Problem A: Functional ECO with Behavioral Change

Guidance

Q&A

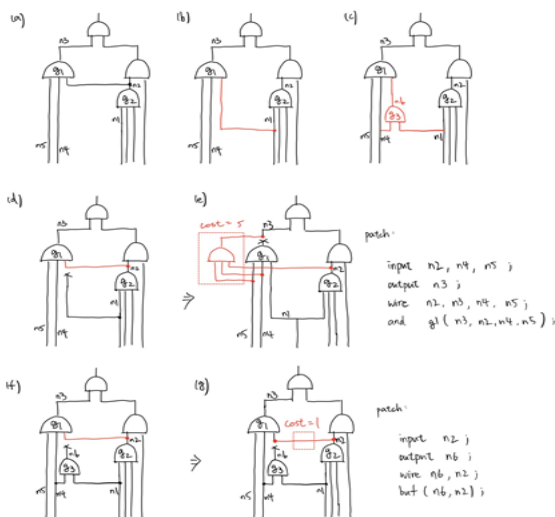
Q12. Could you help to advise if I declare a 8 bits bus in patch file but I only patch 2 bits of it, the number of wires of this bus in cost computation will be 2 or 8?

For example, the patch file is as follows. Does the cost of patch be 2 or 8?

module top_eco (o, in);
input [1:0] in;
output [7:0] o;
wire [1:0] in;
wire [7:0] o;
not n1 (o[0], in[0]);
not n2 (o[1], in[1]);
endmodule

A12. If you only want to patch 2 bits of a bus, you can patch on a single bit. For example, using “`o1[0]`” and “`o1[1]`”. If you patch the whole 8-bits bus, the cost will be 8.
